TM-783

CCI Report No. 370-105

REVIEW OF QUESTIONS POISED BY JEFF APPEL  
ON SATELLITE REFRIGERATOR DESIGN

4 April 1978

FIGURE 1

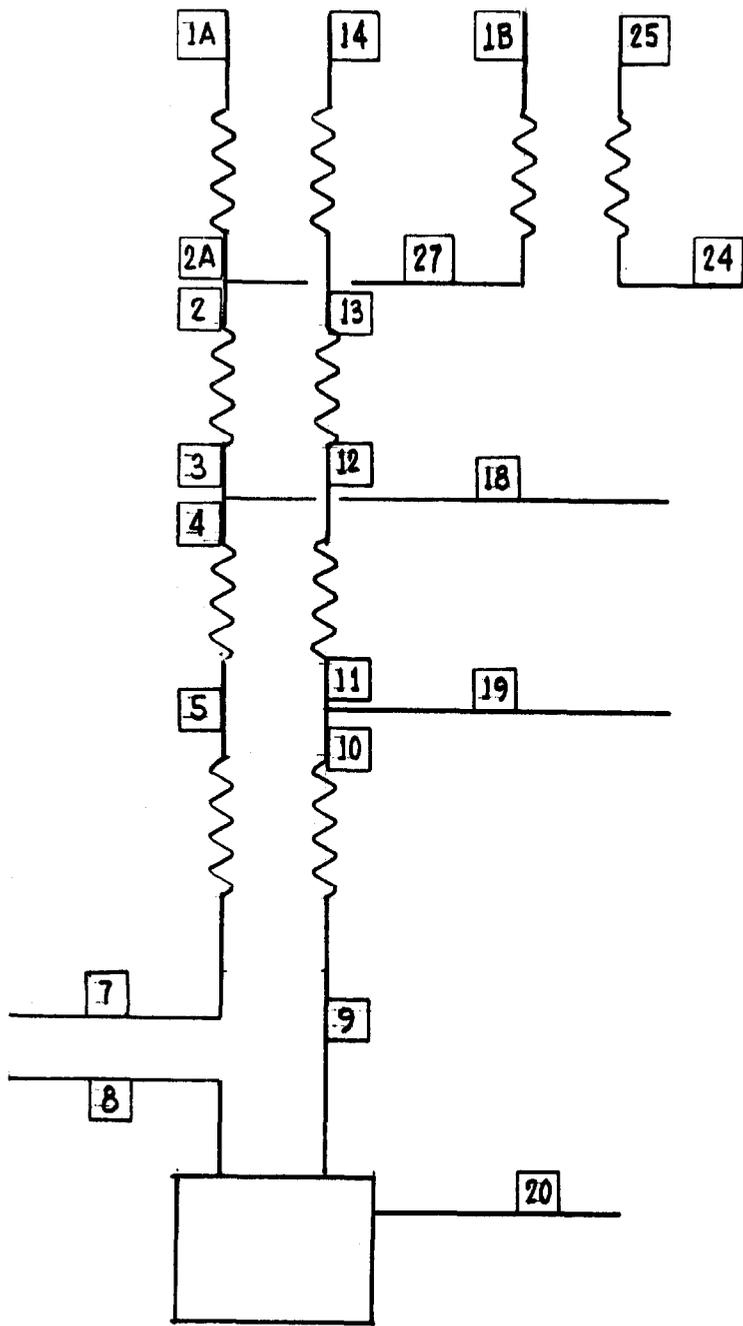
1. What is the temperature between exchangers II and III (high pressure gas) when the refrigerator operates in the satellite mode?
2. Will there be problems in reading the VPT's in the high pressure streams between exchangers II and III, and III and IV?
3. Line Q (80°K) passes through the shell side space between exchangers III and IV. What is the effect of heat transfer in that area?
4. Why do we use Schedule 5 - 10 piping and 2,000 lb fittings in the same assembly?
5. MV-20 is connected through an 1/8" IPS pipe; valves MV-13, MV-14, MV-60, MV-61 and PI-6 through 1/4 in. OD tubes.
6. What tolerances can one put on flattening of the copper tube of exchanger I?

Temperature distribution in heat exchangers during satellite mode operation.- It is assumed that the process of the satellite refrigerator is as shown in Figure 1. Process points are as indicated in Table I:

The Table III data indicate that for exchanger II  $\frac{Q}{\Delta T_m}$  will be approximately 10% larger than the value calculated from Table I. When the temperature of Point 2 drops, duty Q of the heat exchanger will increase, while  $\Delta T_m$  will decrease. To obtain a change of 10%, Q will increase by 4% and  $\Delta T_m$  will decrease by 6%. Then the new temperature of Point 2 will be approximately 71°K.

It should be realized that small changes in flow ratio between streams 1 and 14 will have a significant change on the performance requirements of the individual heat exchangers. For this reason, control of the cold end of exchanger II probably can be exercised with the same vapor pressure thermometer (nitrogen charged).
